### **Variance**

**2728 Cedar Drive, G02020352**

## OFFICE OF PLANNING AND ZONING

### CONFIRMATION OF PRE-FILE

EXISTING CONDITIONS PROPOSED SITE PLAN FOR VARIANCE AND MODIFICATION

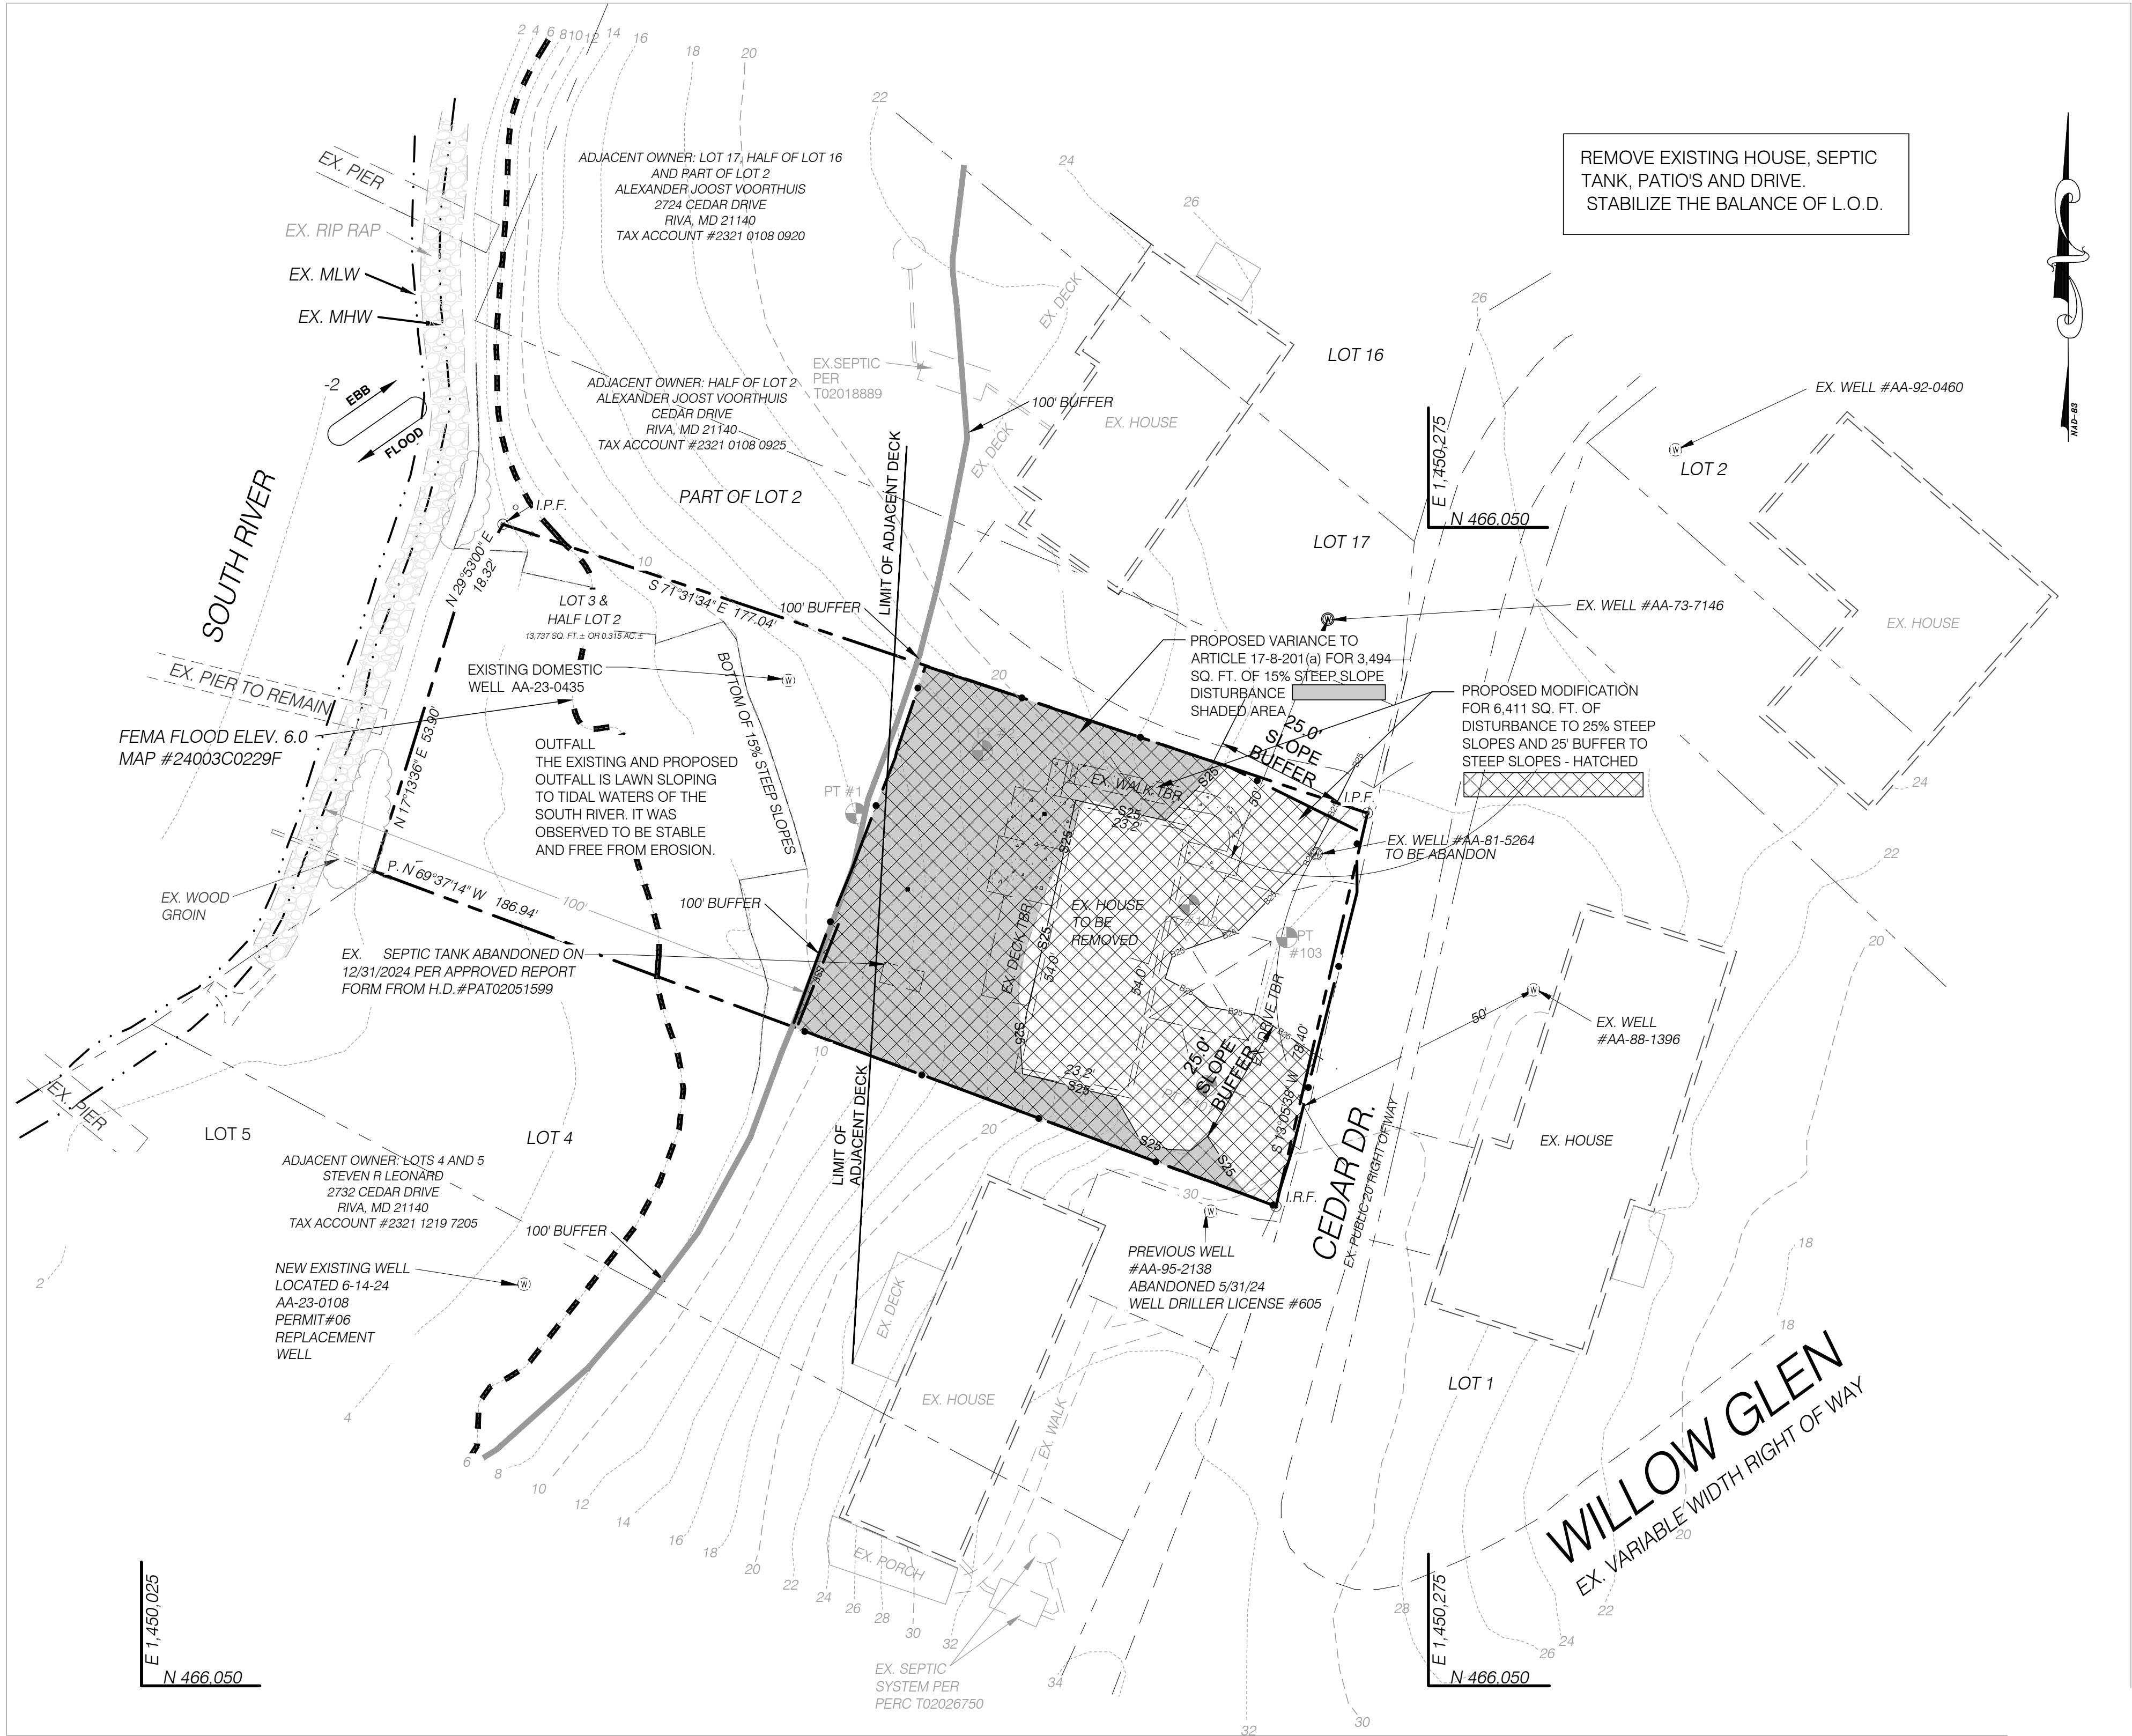
2. The existing conditions are not clear on the site plan. Revise the site plan to eliminate the outline of the proposed dwelling on the existing conditions view.

3. The variance and the modification are reviewed under separate applications, by separate Offices. Revise the site plan to eliminate the modification request information.

4. Revise the site plan to specify the height, number of stories, and whether there will be a basement for the proposed dwelling.
5. The applicants are reminded that, in order for the Administrative Hearing Officer to grant approval of the variances, the proposal must address and meet all of the applicable variance standards provided under Section 18-16-305. The Letter of Explanation should address each of those standards and provide adequate justification for each of the variances required. Specifically, the letter should be revised to provide justification as to the proposed placement of the new dwelling in response to the Critical Area Team comments below.

1. Label all stormwater management devices.
2. The plan shown on the first page of the Site Plan is entitled "Existing Conditions Proposed Plan." Please clarify: is this plan "existing conditions" or "proposed?"

3. According to the "Proposed Site Plan," it does not appear the proposed house will have a basement, since only the first floor and second floor elevations are shown. However, the "Front Elevation," found on Sheet 2 of the Site Plan, shows a marked "basement floor". Please clarify whether or not the proposed house will have a basement.

4. If the proposed house does not have a basement, explain the reason for the excessive grading to the west of the proposed house (especially since the first floor elevation is 34.25 ft, while the contour located directly west of the proposed house shows an elevation of 18 ft).

1. Alignment has been addressed elsewhere.
2. The proposed house has been removed from the existing conditions plan.
3. Is understood that the reviews are separate, in order for clearer client understanding both variance and modification notes are included on the variance. When the modification is prepared, the variance notes will be removed.
4. The site plan includes a building profile with the height of the building which indicates the number of stories including the basement.
5. It is acknowledged that the variance request must address standards for granting a variance. (Placement is addressed below.)

1. SWM devices have been labeled.
2. The plans have been labeled correctly.
3. A profile has been added to the plans which indicates that the house will have a basement.
4. (house has basement).
5. The proposed house has been removed from the existing conditions plan.
6. Swales have been provided along the side of the property to make sure that flows are conveyed to the large rear yard area.
